Access Compliance Report

Public Rights-of-Way

(Curb Ramps)

Intersection ID: 15859	Main Street: CHAR_MECK_LN	Cross Street: MCALWAY RD	Location: SE
ADA ID: 5D867717FEF	Ramp Type: PerpDiag	Initial Pass/Fail: Fail	Overall Compliance: No
Codes/Mitigation Info/Possible Solution			Severity Score: 55
			Field Measurements/Component Compliance

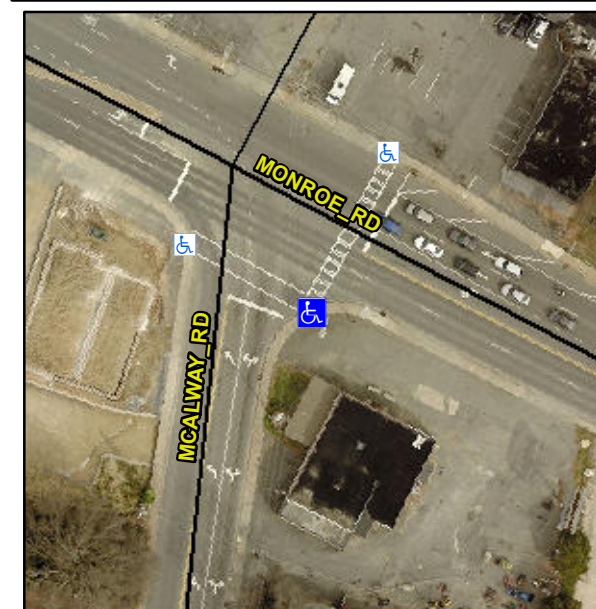
Not Found, R304.5.1, R304.2.2, R304.5.3

Compliance	Description	Data	Compliance	Description	Data
N/A	Ramp Length (in)	80.0	No	Ramp Slope (%)	10.2
No	Ramp Width (in)	35.0	No	Ramp XSlope (%)	7.3
N/A	Flare Type LT	N/A	N/A	Flare Type RT	N/A
N/A	Flare Slope LT (%)	N/A	N/A	Flare Slope RT (%)	N/A
N/A	Flare Traversable LT?	N/A	N/A	Flare Traversable RT?	N/A
N/A	Landing Length (in)	N/A	N/A	DWS Provided?	N/A
N/A	Landing Width (in)	N/A	N/A	DWS Contrast?	N/A
N/A	Landing Slope (%)	N/A	N/A	DWS Length (in)	N/A
N/A	Landing X Slope (%)	N/A	N/A	DWS Full Width?	N/A
N/A	Landing Curb? (Y/N)	N/A	N/A	DWS Offset (in)	N/A
N/A	Shared Landing?	N/A			
N/A	Gutter Ponding?	N/A	N/A	Gutter Slope (%)	N/A
N/A	Gutter Lip Ht (in)	N/A	N/A	Gutter X Slope (%)	N/A
N/A	Painted X Walk1?	Yes	N/A	Painted X Walk2?	Yes
	X Walk 1 Direction	To NE		X Walk 2 Direction	To NW
N/A	X Walk 1 Width (in)	84.0	N/A	X Walk 2 Width (in)	108.0
	X Walk 1 Slope (%)	9.8		X Walk 2 Slope (%)	0.6
	X Walk 1 X Slope (%)	1.2		X Walk 2 X Slope (%)	8.6

Remove & Replace Curb Ramp With Two New Directional Ramps or Equivalent.
